Request for Wetland Buffer Modification

***HGL Investment Properties
102XX 124th Avenue N.E.***

Re: HGL Investments Project/Larson Property – Wetland Buffer Modification Plan Review. The Watershed Company Reference Number: 140622.21

Re: HGL Investments Project/Larson Property – Revised Wetland Buffer Modification Plan Review. The Watershed Company Reference Number: 140622.21

Buffer Enhancement Plan

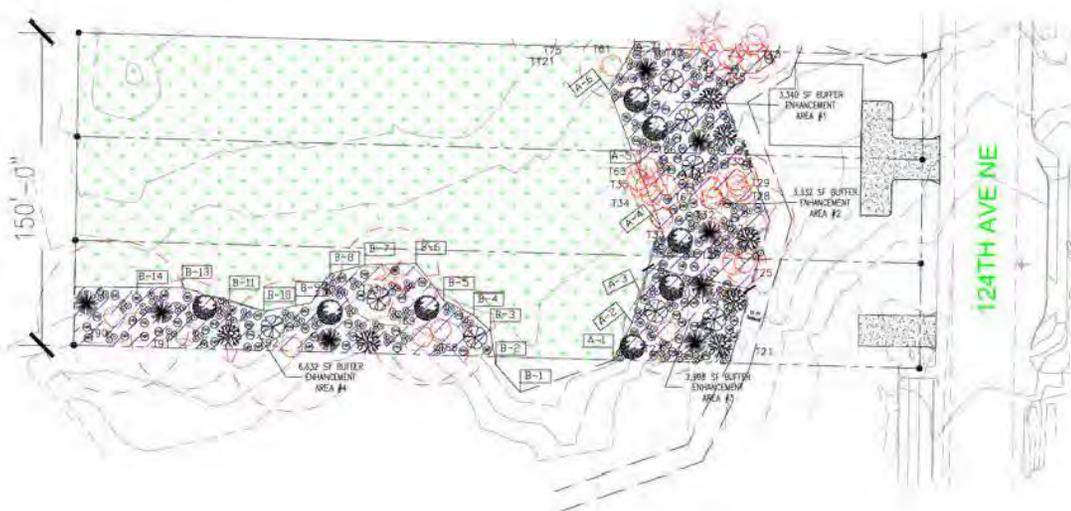
1. There is a discrepancy in the restoration area numbers. The notes on mitigation plan sheets 1 and 4 list 16,002 square feet while the four restoration areas listed in the plan view drawing on sheet 2 total 16,302.

2. The proposed planting density appears low. The existing native vegetation is not mapped and therefore, an accurate number of needed plants cannot be determined. Most of the native plants are salmonberry, a few other shrubs and alders in poor condition. These areas are almost completely overgrown with invasive Himalayan blackberry, English holly and ivy. It is likely that many of the existing native shrubs will be damaged during the weed removal effort. Therefore, the site should be considered almost entirely open for replanting with native species. Per past successful mitigation sites in Kirkland, a completely open site of this size should be planted with 196 trees and 456 shrubs. These numbers follow King County recommendations for forested buffer restorations.

3. No large woody debris or other habitat structures are proposed. Habitat structures should be proposed to more effectively improve wildlife habitat. *A Woody debris requirement has been added to mitigation plan sheet 2, note number 3. However, debris should also be shown on the plan so the contractor can better understand the distribution and approximate locations of individual pieces. For instance, the southern buffer enhancement area should not have any debris proposed since it would require traversing either private property or the wetland to access that area.*

- Notes:
- 1) Approximately, the south one-third of the west buffer will be completely cleared, because of dense Himalayan blackberry. The remainder of the west buffer and entire south buffer will have hand removal of invasive plants. Native plants, including salmonberry, trailing blackberry, red alder and others will be retained in the buffer.

- 2) The standard planting density requirement of 190 trees and 456 shrubs. The contractor will be required to meet the plant the standard planting density totals for trees and shrubs. If not met the contractor will be required to add plants. Existing native plants, in good condition, will be allowed to be counted in the plant totals to meet the standard planting density requirement.

- 3) All existing snags and large wood debris will be retained in the buffers. These snags and six 12-foot long logs will be added to the west buffer. The source for these will be from existing trees in the proposed development areas. The location for placement of wood will be determined by the environmental consultant during clearing activities.

1. There is a discrepancy in the restoration area numbers. The notes on mitigation plan sheets 1 and 4 list 16,002 square feet while the four restoration areas listed in the plan view drawing on sheet 2 total 16,302. *The plans are now consistently using 16,302 square feet for the total enhancement area.*
2. The proposed planting density appears low. The existing native vegetation is not mapped and therefore, an accurate number of needed plants cannot be determined. Most of the native plants are salmonberry, a few other shrubs and alders in poor condition. These areas are almost completely overgrown with invasive Himalayan blackberry, English holly and ivy. It is likely that many of the existing native shrubs will be damaged during the weed removal effort. Therefore, the site should be considered almost entirely open for replanting with

native species. Per past successful mitigation sites in Kirkland, a completely open site of this size should be planted with 196 trees and 456 shrubs. These numbers follow King County recommendations for forested buffer restorations. *Density has been increased. Plan sheet 2 contains the following note: "The standard planting density requirement of 196 trees and 456 shrubs. The contractor will be required to meet the plant the standard planting density totals for trees and shrubs. If not met the contractor will be required to add plants. Existing native plants, in good condition, will be allowed to be counted in the plant totals to meet the standard planting density requirement."* The first sentence is unclear since it is incomplete and also does not reflect the proposed number of trees on the plan (168). The second sentence was suggested to give the contractor an incentive to avoid over-clearing and is appropriate.
